WORK INSPECTION REQUEST (WIR) FORM

Contractor:	HAIF-FREYSSINET JV
Project:	RA2RC
Contract No.:	QPMO-410-CT-00618
Work Inspection Request Number:	QRXM114000-HFC-TEC-WIR-ITS-02-RO5-00002

Inspection request for Installation of Variable Message Sign (VMS)-5nos and 7mtr ITS Pole-5nos VMS-01,VMS-02 ,VMS-03 ,VMS-04 ,VMS-05 .Main Line-02 and Spiliting.

Project Name: Package 3 - Interim Road Access to Resort Core	**Project Code:** QRXM114000
**Location: RA2RC ** Qiddiya INTERM ROAD	**Date:** 14-February-2026
Document Title: Method of Statement for Installation and Commissioning of Intelligent Transportation System Equipment and Devices.	**Ref No: QRXM114000-HFC-TEC-MST-ITS-02-RO5-00001** **Rev No:** 00

ITS POLE - 7M

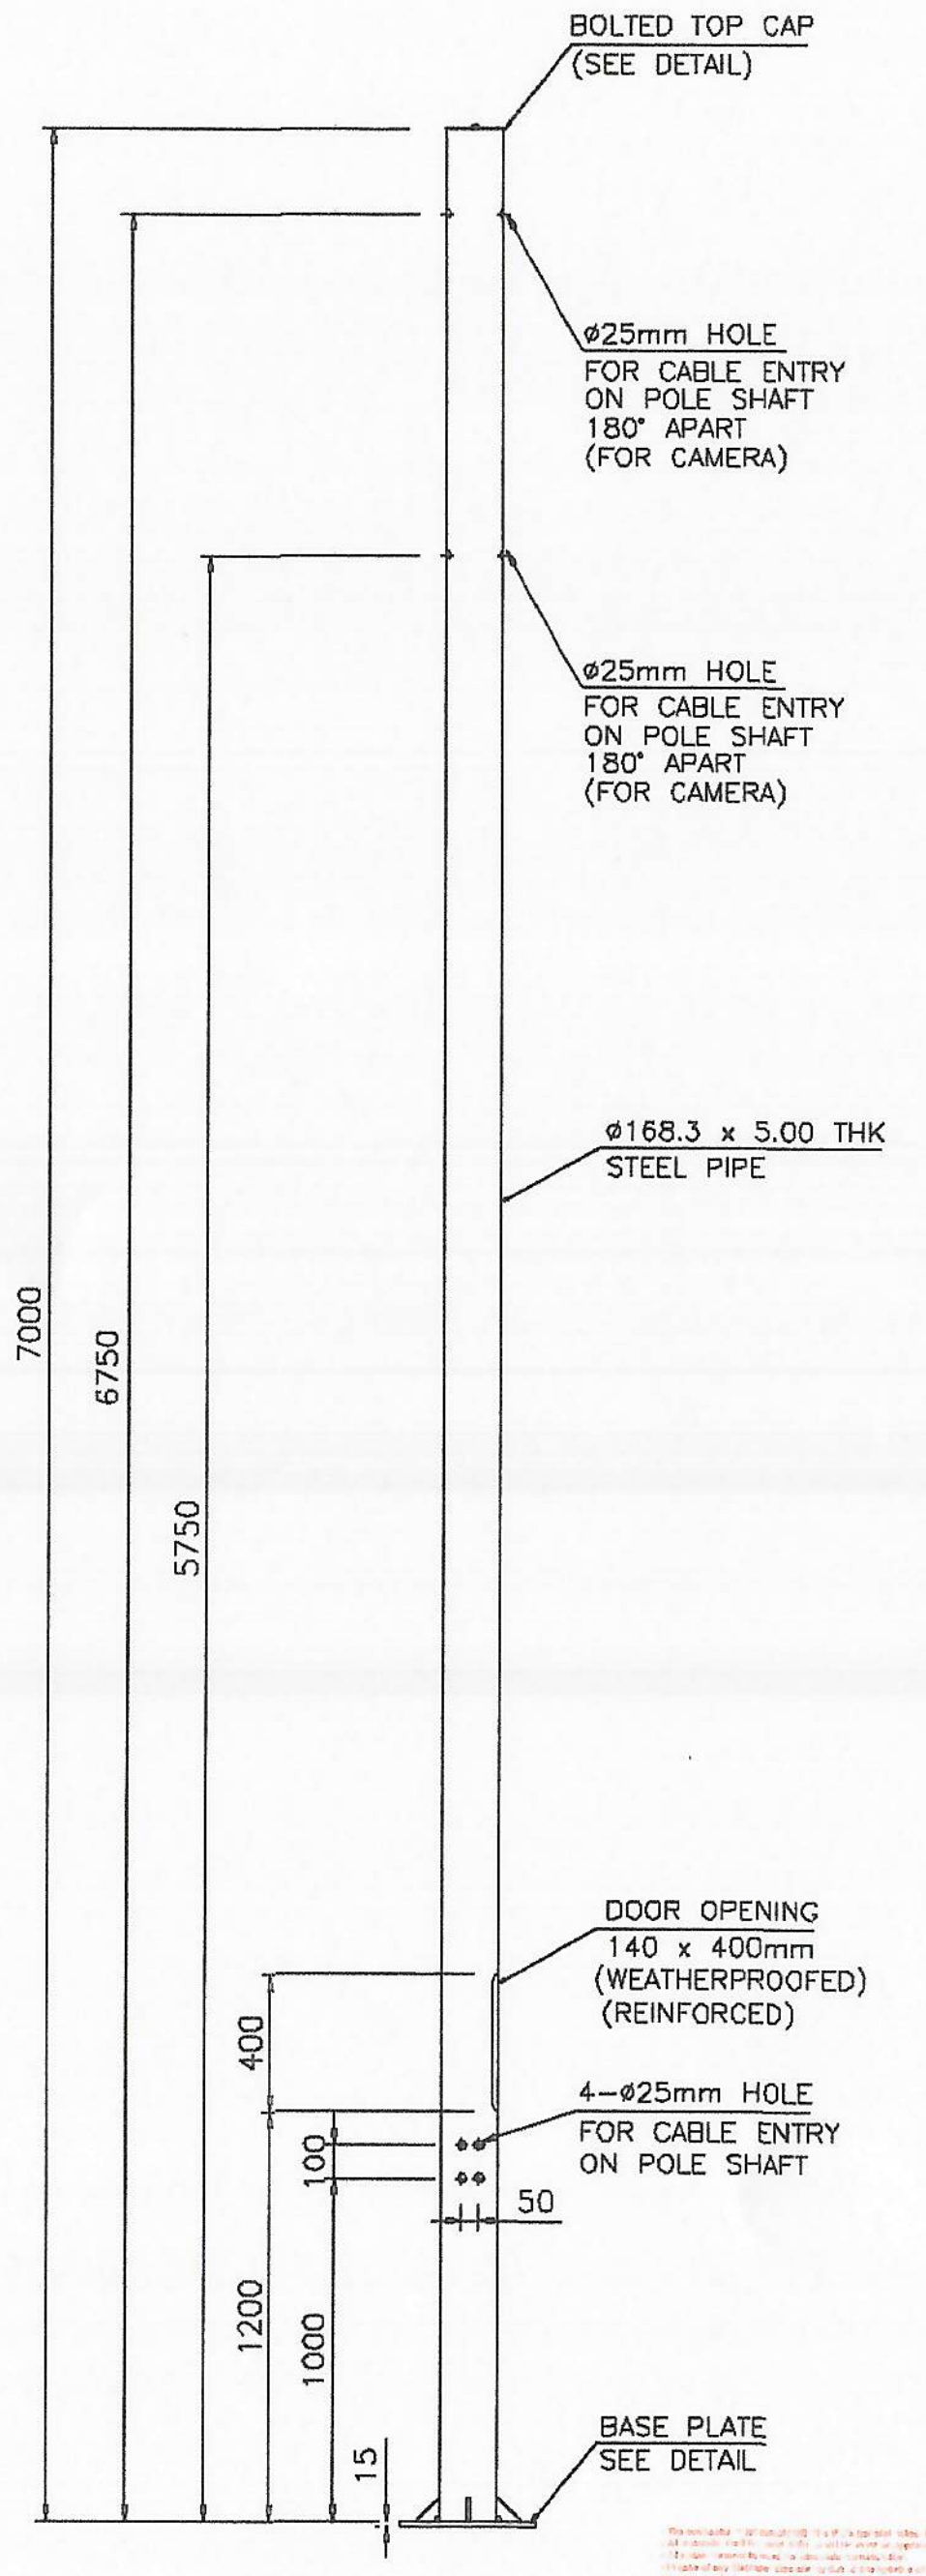
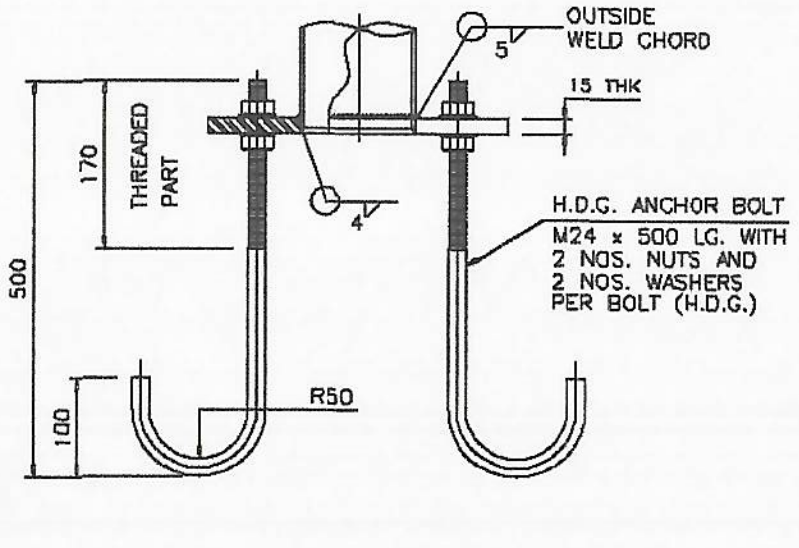
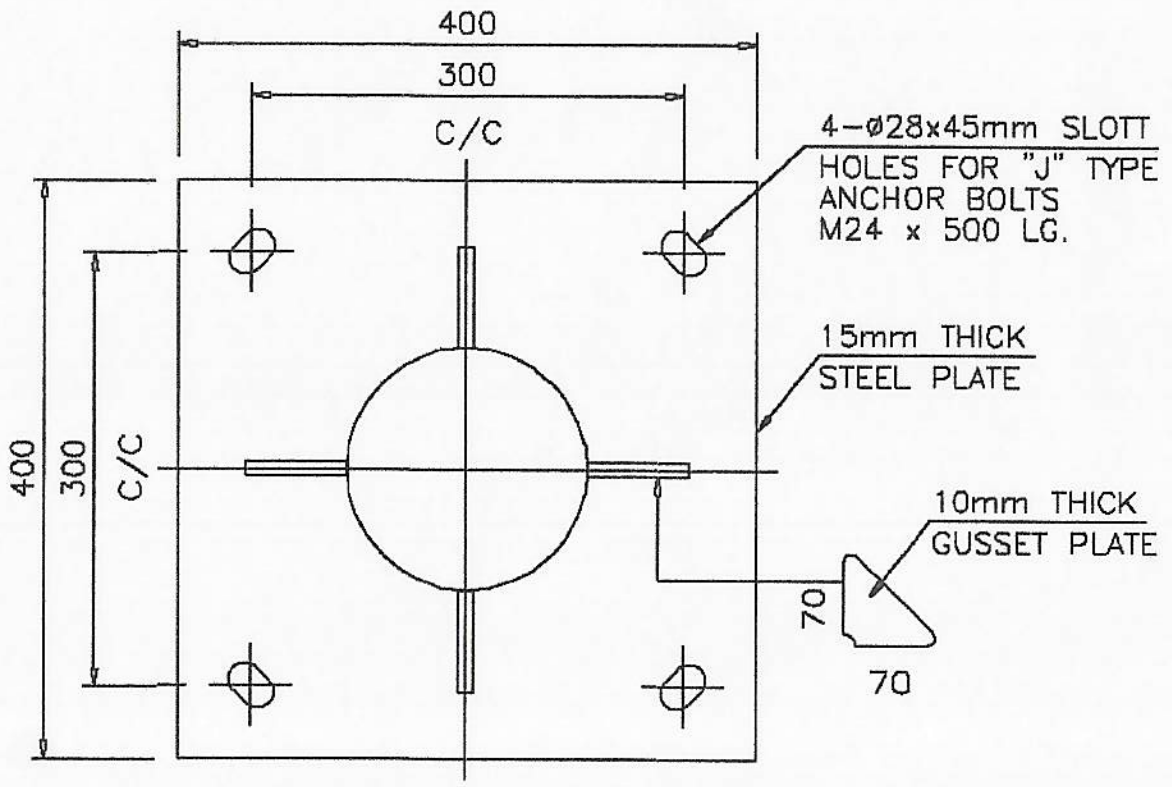
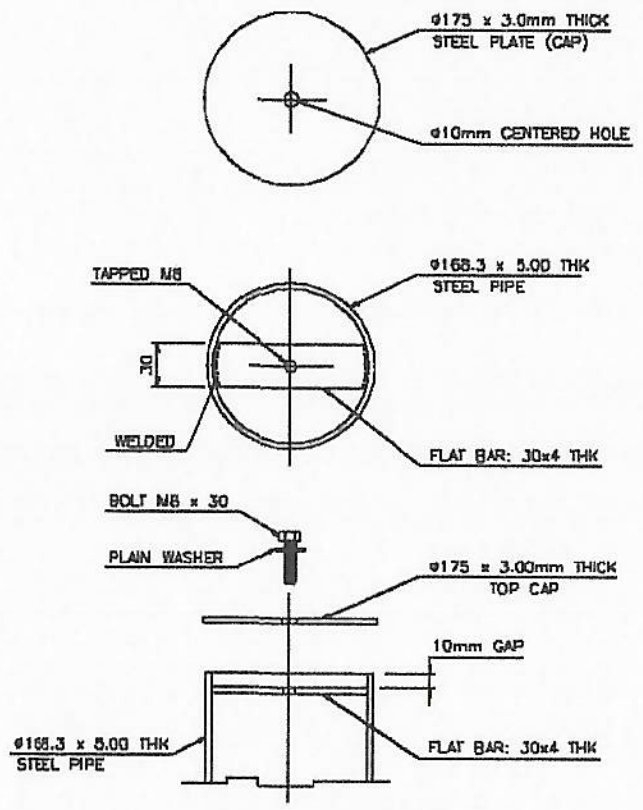
Pole specification shall be as per pole manufacturer recommendation
